# DMURS Quality Audit

Proposed Large Residential  
Development at Castlelands,  
Mallow, Co. Cork

Reside (Castlepark) Ltd

DMURS Quality Audit

**Photograph 1: View East of Kingsfort Avenue Raised Crossing**

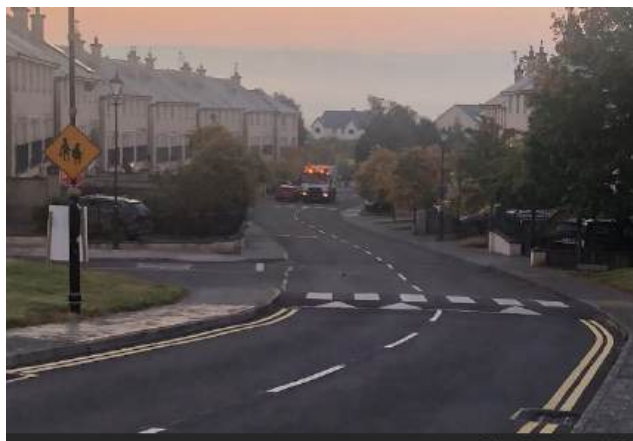
Footways are provided along both sides of Kingsfort Avenue. A vertical traffic calming ramp is provided on Kingsfort Avenue adjacent to its St. Joseph's Road junction. A raised table Stripe marking pedestrian crossing facility is provided on Kingsfort Avenue, immediately west of its Scoil Aonghusa Community National School access junction, as shown in the hereunder photograph. A series of vertical traffic calming ramps are provided along Kingsfort Avenue east of the raised pedestrian crossing facility.

### 3.2.2 Uncontrolled Pedestrian Crossings

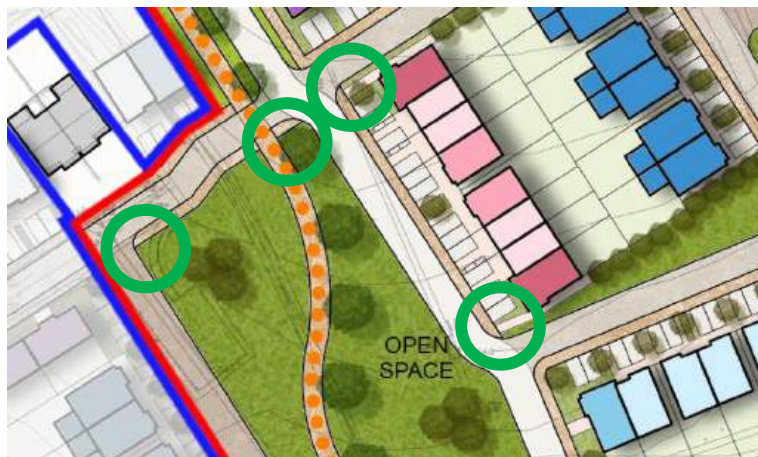
**Problem:** The proposed development indicates footpaths terminating at the junction radii. It is not clear how these footpaths will incorporate dropped kerbs or tactile paving. In some cases, the footpath does not align with the continuation on the opposite side of the road.

**Hazard:** Sight or mobility impaired pedestrians may errantly enter the carriageway into the path of oncoming traffic. Wheelchair and mobility scooter users may be at risk of overturning when negotiating full height kerbs and may be impeded when crossing the carriageway.

**Recommendation:** Suitable dropped kerbs and tactile paving should be provided on all anticipated pedestrian desire lines. The footpath alignment should provide clear continuity to safely connect to the footpath opposite, or lead pedestrians into a clearly defined “shared space”.

### 3.2.5 Crossroads Junctions

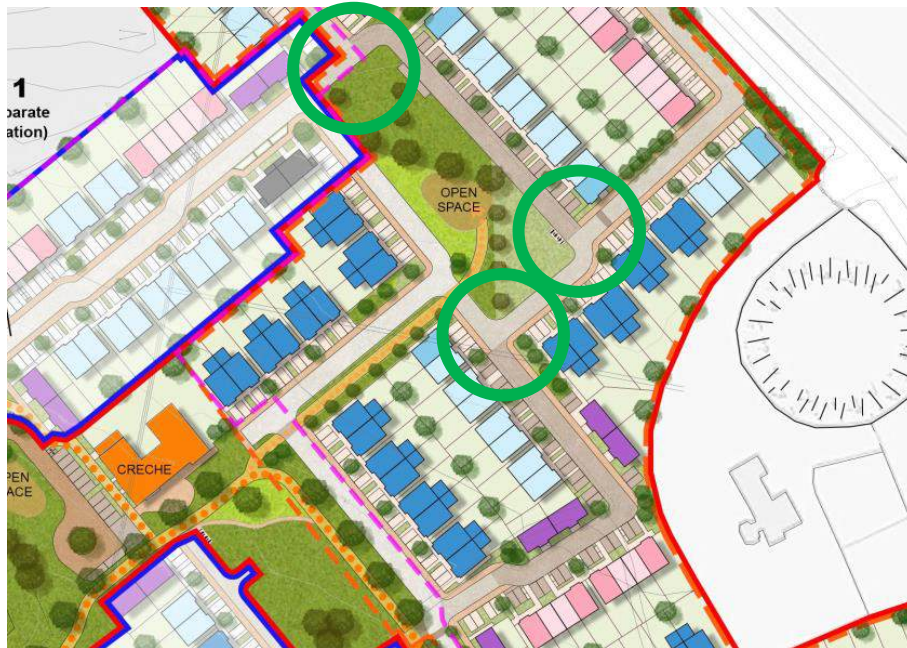
**Problem:** There are crossroads junctions proposed within the LRD development.

**Hazard:** Crossroads junctions have a poor collision history of overshoot type collision.

**Recommendation:** The design team should omit the crossroad junction.
